TRANS/WP.15/2000/12
6 March 2000

**PROPOSALS TO ALIGN TWO PARTS OF ADR COVERING THE FITTING OF SAFETY VALVES TO
PRESSURISED TANKS/TANKERS**

Safety Valves - Marginals 211 233 and 212 233

Transmitted by the European Liquefied Petroleum Gas Association (AEGPL)

COMPARISON OF RELIEF VALVE CAPACITY ACCORDING TO CURRENT ADR AND CAPACITY ACCORDING TO U.N. FOR PORTABLE TANKS (PROPOSED TO BE INCLUDED IN ADR)

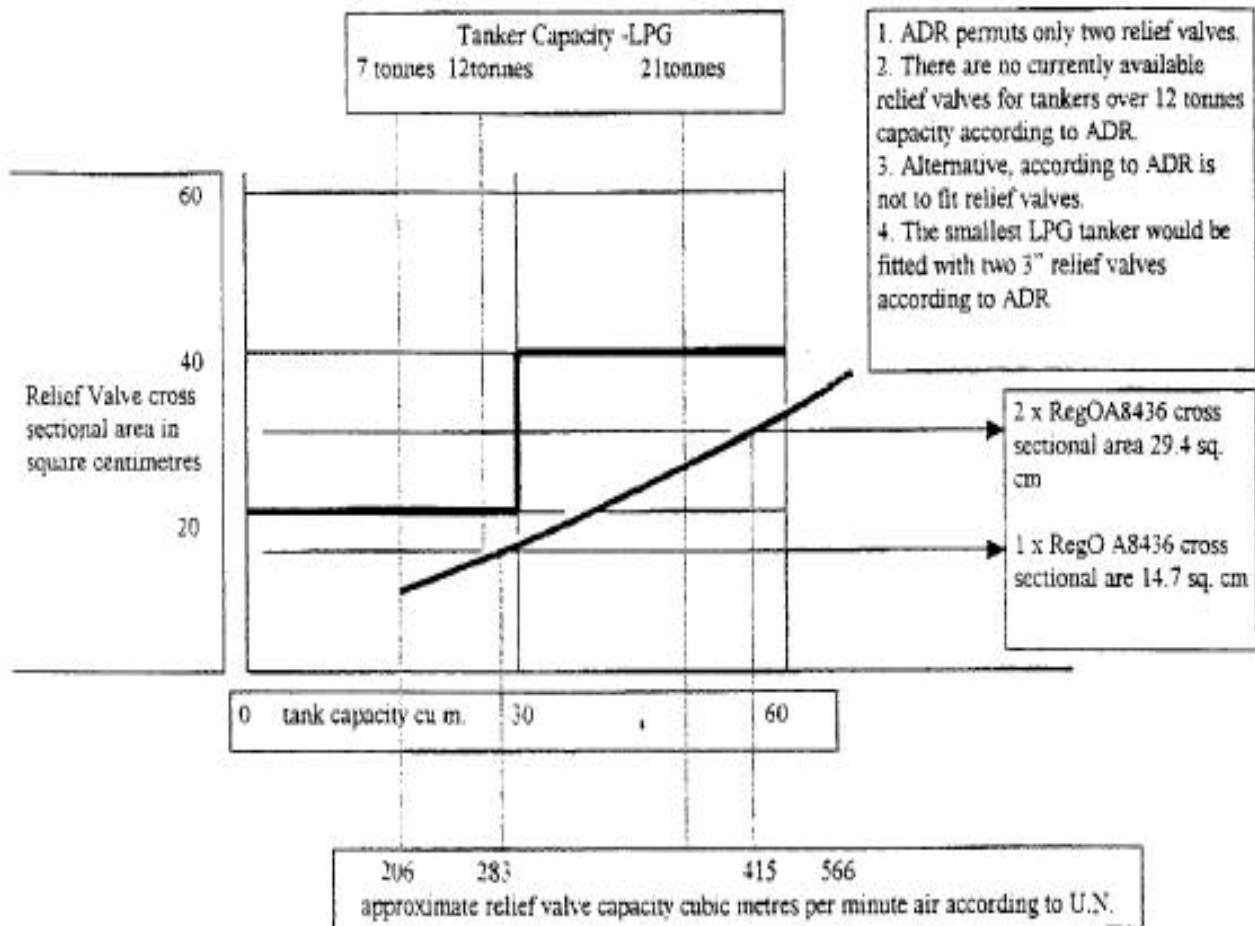
ADR requires 20 square centimetres of aggregate cross sectional area per 30 cubic metres or part thereof of tank capacity. The illustration shows that from the smallest capacity tanker to one of 30 cubic metres - 20 square centimetres of relief valve area is required. For a 31 cubic metre tank - 40 square centimetres of relief valve area is required. Only 2 relief valves are permitted.
